TOWN OF SHALLOTTE

December 19, 2024

RE: Solserra PUD (Master Plan) & Annexation ANX 24-27 Parcel ID # 1980000205, 198JB00115, 198JC001, 198JC002, & 198JC003

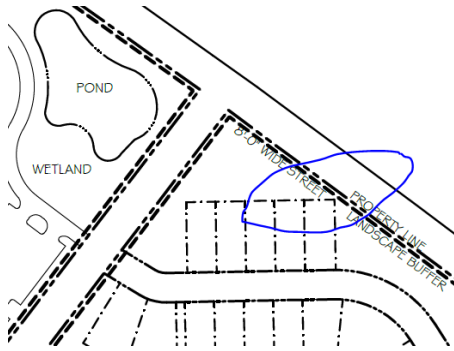
7. Verify sight stopping distance is met without obstruction – particularly here at Tar Landing Rd: **REVISED AND MOVED AWAY FOR PROPERTY LINE AND BUFFER**
